**SUBDIVISION & PLANNED UNIT
DEVELOPMENT STAFF REPORT****Date: August 18, 2016**

| <u>SUBDIVISION NAME</u> | Liberty Motors Subdivision |
| <u>CONTEMPLATED USE</u> | Subdivision approval to create one legal lot of record; and Planned Unit Development to allow multiple buildings on a single building site. |

SITE PLAN

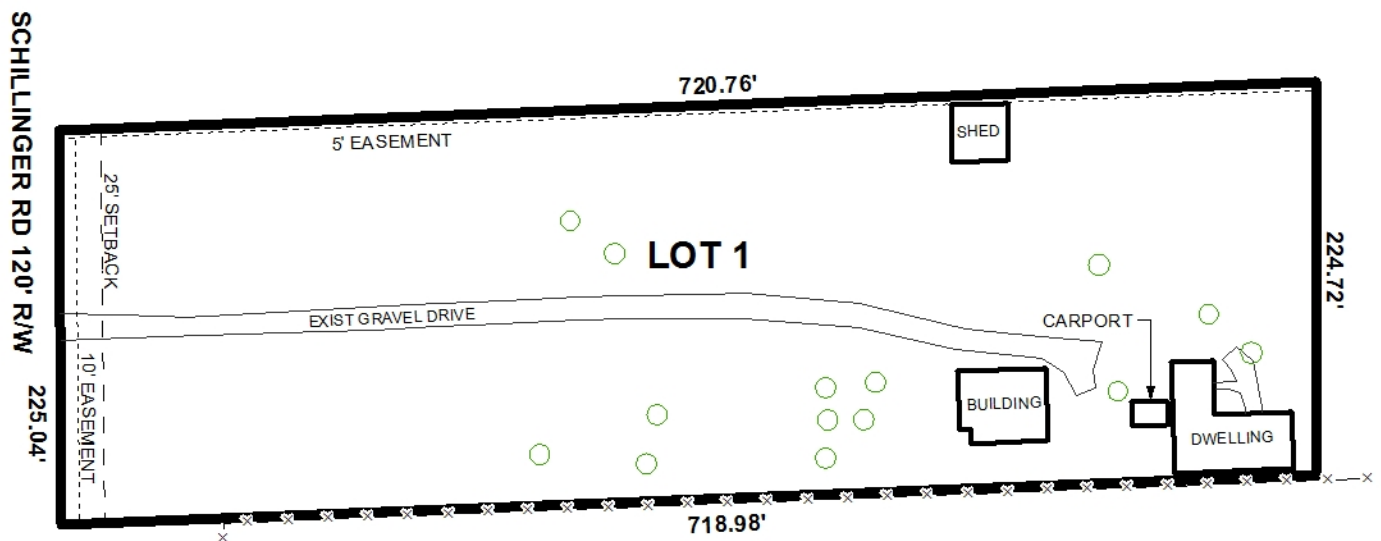
The *Site Data* information on the site plan states that the rear yard setback is 122' from the project site area; however, this cannot be appropriately determined due to the entire subject site not being illustrated on the site plan. The "master site plan" that is included on the site plan indicates that the rear of the proposed project site measures approximately 119' to the rear yard property line of the entire subject site, but it does not depict all proposed and existing site improvements. As PUD approvals are site plan specific, the site plan should be revised to illustrate the entire site with all proposed and existing improvements.

area in square feet on the illustration or in the *Site Data* information. Also, the frontage and perimeter tree planting calculations are missing for the entire site in the *Site Data* information as well. Furthermore, while the site plan illustrates trees being provided, it does not indicate, via a note or in the legend, which proposed trees are overstory or understory trees, or the species of each tree. It appears that more trees are required for this site than what is being proposed; thus, the site plan should be revised to indicate compliant landscaping, tree, and parking calculations for the entire site.

The parking space dimensions, access widths, as well as the drive aisle widths to the East, South, and West of the subject property appear to reflect Zoning Ordinance compliance; however, the drive aisle located on the North side of the property, in addition to the *Auto Display* aisles, are only depicted as 20' in width. The site plan should be revised to depict 24' aisle widths to accommodate two-way traffic for all proposed drives.

The front setback line is depicted as 10' on the site plan; however the Zoning Ordinance requires a distance of not less than 25' from the front property line in B-3 zoned districts. The site plan should be revised to depict a minimum building setback line distance of 25' in order to reflect compliance with the Zoning Ordinance and match the preliminary plat.

The location and dimensions of the proposed HVAC mechanical equipment for the proposed one-story office building structure is not illustrated on the site plan. The site plan should be revised to indicate the location, height and size of the HVAC mechanical equipment in compliance with Section 64-4.D.11 of the Zoning Ordinance.

The site plan does not indicate the method of garbage collection for the subject site. The site plan should be revised to illustrate that onsite garbage collection will be served via a dumpster with a connection to sanitary sewer in accordance with Section 64-4.D.9 of the Zoning Ordinance or the placement of a note on the site plan indicating such. Or, a note should be placed on the site plan stating that garbage collection will be provided via curbside or by private garbage collection services if a dumpster will not be provided.

A sidewalk is not depicted and labeled along the property's frontage on the site plan. If a sidewalk is not being proposed within the development of this site then a sidewalk waiver must be obtained, or a sidewalk must be provided and be clearly indicated on the site plan.

It should be mentioned that seven (7) heritage trees are required in the front setback area, but the tree locations are unclear on the site plan due to the placement of wording in the front setback. The site plan should be revised to provide more clarity within the 25’ minimum setback area so that the heritage trees and notes are legible; however, it should also be noted that the frontage trees required, and those being proposed, are listed in the “Site Data” section of the site plan as well. Also of note, is that some of the proposed frontage trees appear to be understory. All required frontage trees should be overstory trees.

The site plan should be revised to ensure that all applicable parking space stalls, especially those located in front of the office building, are equipped with wheel stops or curbing to prevent encroachment into landscaped areas, sidewalks, and buildings.

The 25' minimum building setback is illustrated appropriately for the site; however, the "10' Front Setback Line" should not be indicated on the site plan, as it is misleading. If approved, the Final Plat and site plan must depict the removal of the "10' Front Setback Line."

It should be noted that that existing storage building located at the southeast corner of the site has a side yard setback of distance 3.7'-3.8' from the property line. The Building Code requires that all structures located less than 5' from residentially-zoned property be fire-rated. The applicant should confer with the Chief Building Inspector, as the site plan may have to be adjusted to meet Building Code compliance.

- 1) *Revision of the "Tree Credit Details" section on the site plan to indicate the required number of trees needed for the parking area;*
- 2) *Retention of the note stating that the method of garbage collection will be provided by curbside, private garbage collection service;*

- 3) *Revision of the site plan to provide more clarity within the 25' minimum setback area so that the heritage trees and notes are legible;*
- 4) *Removal of the "10' Front Setback Line";*

- 5) *Retention of the 25' minimum building setback line;*
- 6) *Revision of the site plan to depict all proposed frontage trees as overstory trees;*
- 7) *Revision of the site plan to illustrate curbing or bumper stops for each parking space abutting landscaped areas and buildings;*
